**8. 2006SP-183U-09**

Broadway Hotel

**APPLICANT REQUEST - Amend SP**

Sky Exposure Plane of the proposal (left) and adopted SP plan (right), with height labeled

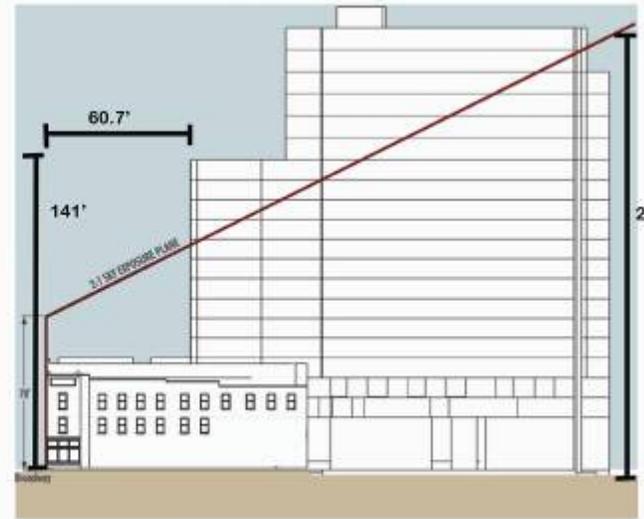
In addition, the Second and Broadway DNDP limits development to a 2:1 sky exposure plane. This sky exposure plane is intended to limit the impact of new development on the Broadway Historic District. The placement of structures within this sky exposure plane is consistent with the existing buildings on Broadway, which have historically been human-scaled, ranging from two to five stories. Below is a diagram of the sky exposure plane applied to the adopted SP plan and proposed SP plan. As demonstrated, the tower is taller in the portion of the building closest to Broadway.

**PLAN DETAILS** The boundary of the proposed SP amendment remains the same as the adopted SP plan. The site includes everything between Broadway, 2nd Avenue South, 3rd Avenue South, and the Shelby Street Bridge, with the exception of two properties. The plan calls for a maximum of 475 hotel rooms and associated retail and restaurant uses. The adopted SP plan is approved for 375 hotel rooms and 48 condominiums. The retail and restaurant uses are oriented to pedestrian activity on Broadway. The restaurant is within the rehabilitated historic buildings, along with a small number of hotel rooms. The remainder of the hotel rooms are within the tower. The base of the building is three stories and the tower, which is setback 60' from Broadway, is 16 stories, or 186 feet, at the highest point. The approved plan included base of three stories and a tower that was set back 60.7 feet from Broadway and was 19 stories, or 201 feet, at the highest point. The portion of the tower closest to Broadway is taller, at 157 feet, than in the approved plan, which was 141 feet. (See Sky Exposure Plane graphic above.)

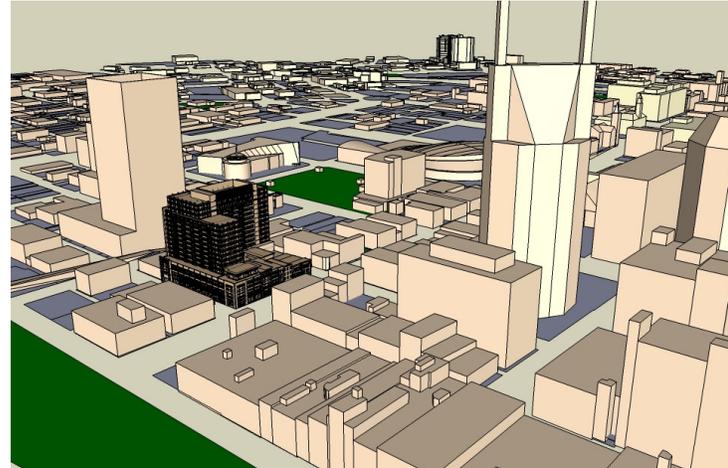
Currently, the proposed street façade buildings for the Broadway Hotel that face directly onto Lower Broadway do begin to create a similar rhythm and repetition with their windows as what historically exists along Lower Broadway. For new construction to be compatible with the existing historic structures on the site, the connection to them is critical and the current design should be revised to be more appropriate. The connection between the new addition and the historic structures on site should relate in mass, scale and form while remaining subordinate to the main structure. Because the new Broadway facade addition is larger than the original historic structures, the 'link' between the two should be small, recessed, and not dominate the façade.

Also, the new Broadway façade should break up the mass of the addition into smaller modules that relate to the historic building's massing. Other than the 'link' between the new addition and the historic structures, the applicant has done a good job of keeping the Broadway facade addition simple in design to remain consistent with the historic facades along Lower Broadway. The elevation along Third Avenue has a better design approach to attaching the new addition to the historic building. The new addition design should be refined to be pedestrian-friendly and work to create a strong, active street presence along Third Avenue. The elevation along Second Avenue is successful at creating a pattern and rhythm along the street with the repetition of evenly-spaced, similarly-sized, upper story windows until you get to the bay closest to the parking garage entrance. The applicant should refine the design of this bay to be more consistent with the Second Avenue façade.

Example as suggested in Condition 1 text

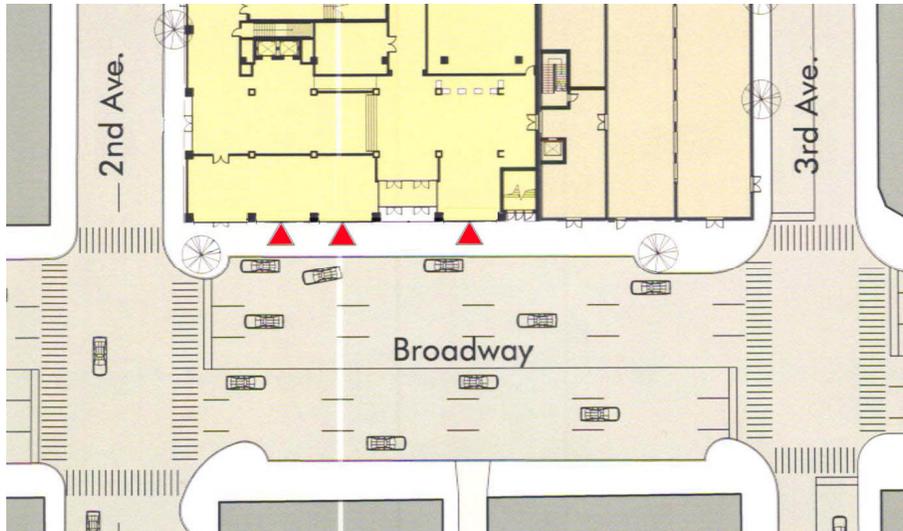
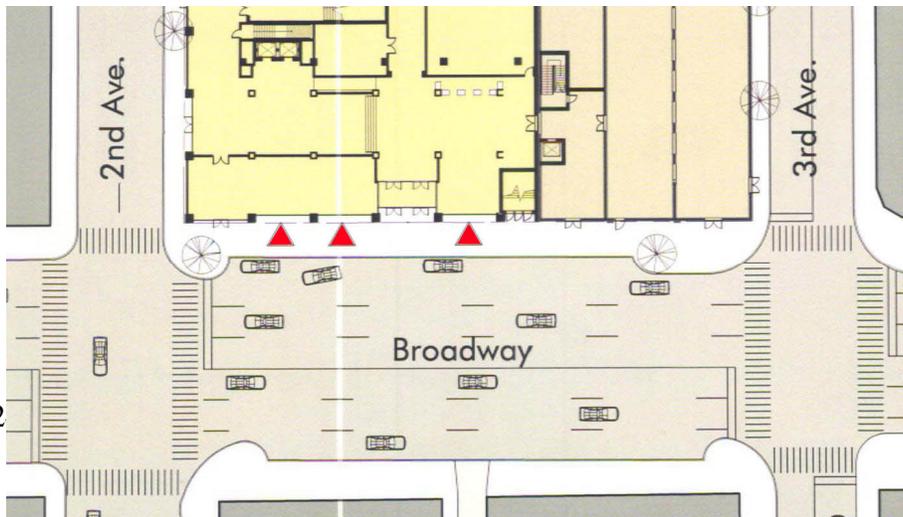
1. The Broadway street façade shall be pulled up to the property line with recesses and step-backs along the building edge only for entrance and design transition from old-buildings-to-new purposes. The street elevation of the new structure shall be in the same plane as the original 'historic' facades, in order to be consistent with other buildings in the historic streetscape. Although similar in form and materials, the composition and details of the new façade are to be more simplified. The design transition from old-buildings-to-new shall be reinforced by the narrow recessed connector.
